APPLICATION NO.	FILING DATE	FIRST NAMED INVENTOR	ATTORNEY DOCKET NO.	CONFIRMATION NO.
10/040,472	01/09/2002	Kia Silverbrook	AP17US	2552
24011	7590	07/30/2004	EXAMINER	
SILVERBROOK RESEARCH PTY LTD			TRAN, LY T	
393 DARLING STREET			ART UNIT	
BALMAIN, 2041			PAPER NUMBER	
AUSTRALIA			2853

Office Action Summary	Application No. 10/040,472	Applicant(s) SILVERBROOK ET AL. 	
	Examiner Ly T TRAN	Art Unit 2853

DETAILED ACTION

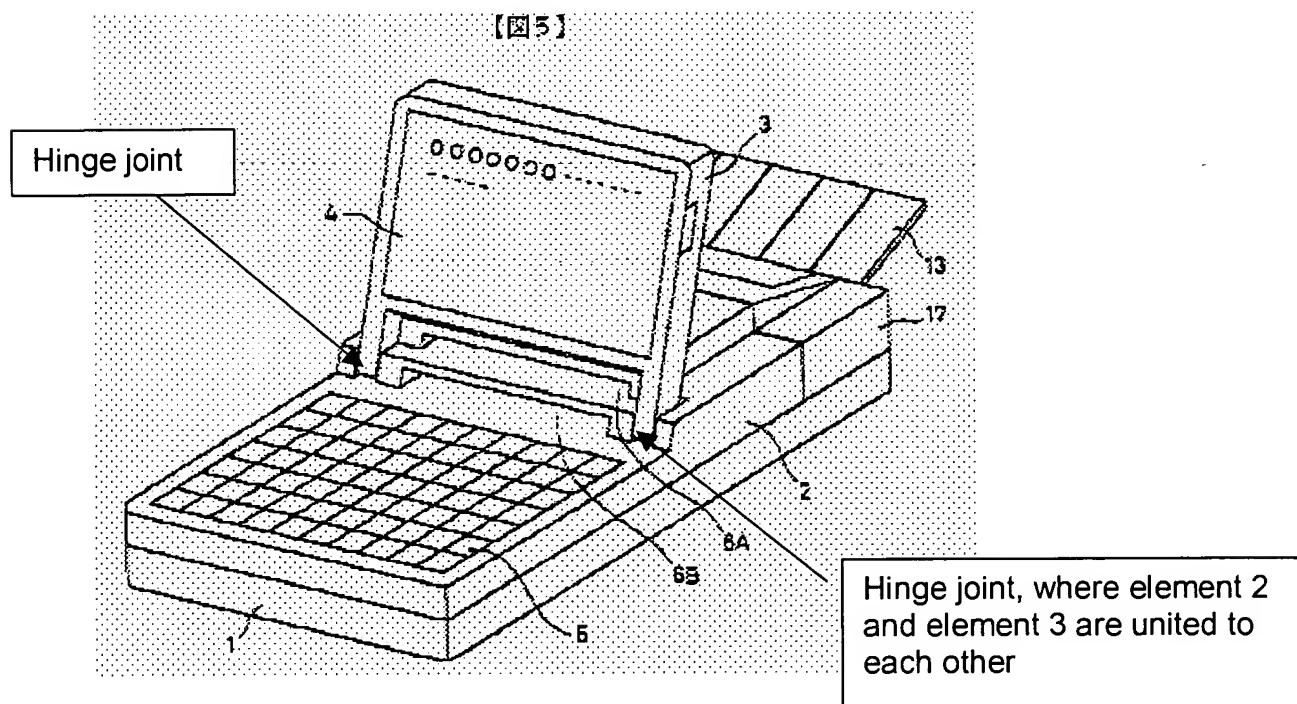
With respect to claim 5, Suzuki discloses a personal digital assistant including a body section (Fig.5) connected to a display (element 4) through a hinge joint (see figure 5 below, by the definition the hinge joint is a part or space included between two articulations, since the space 5A and 5B are included between two articulations, that is the space 5A, 5B are also a part of the hinge joint), a printer at least a portion of which is disposed in the hinge joint (Fig5: 6A and 6B are feed opening which is a part of the printer), input means allowing a user to enter and store new information in the memory (Element 5), because it's a laptop computer, it's necessary to have a memory housed within the body section and a controller housed within the body section and allowing a

user to selectively retrieve information from the memory, to display information on the display and to print information using the printer.

With respect to claim 6, Suzuki discloses supply of print media is disposed in the hinge joint (Fig.5 shows the feed opening 5A, 5B are in the hinge joint, the paper is fed through the opening therefore, the supply of print media disposed in the hinge joint).
